**FIELD OBSERVATION REPORT - Bid #14**

Permit No. 18-131555-00 BC  
 Owner: Vinlege Grand Condo Assn, Inc.  
 Project Address: 4017 Crookers Lake Blvd., Sarasota, FL  
 Contractor: RL James Inc  
 Inspector (s): Mark Boas PM  
 Type of Assessment: Progress

PROJECT NAME:  
**WOOD FRAME REPAIRS & RELATED WORK  
 (PHASE II)  
 VINTAGE GRANDE CONDOMINIUM  
 ASSOCIATION, INC.  
 4012 CROCKERS LAKE BLVD.,  
 SARASOTA, FL 34238**

**PHOTOGRAPH #5**

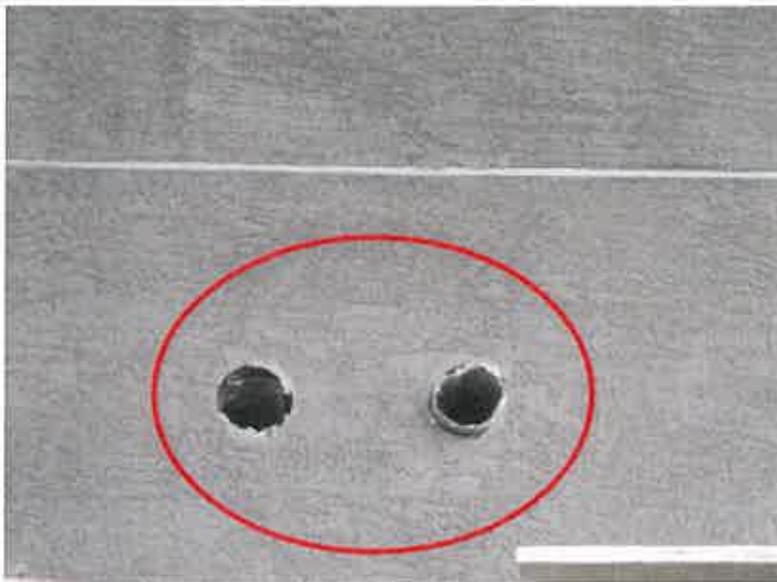
Kick out flashing is above existing roof shingles. Contractor to remove and reinstall per contract drawings.

**PHOTOGRAPH #7**

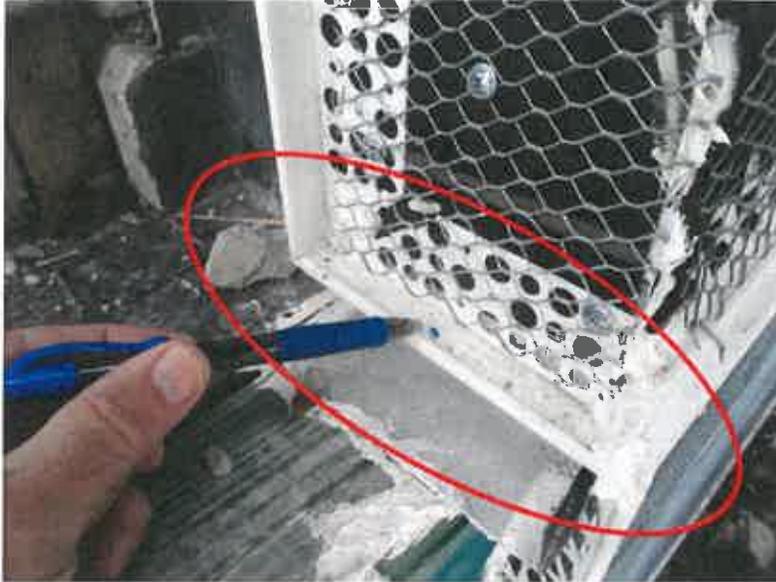
Contractor to use weep screed with holes or provide holes when using stucco stop accessories above flashing at balcony as per drawings.
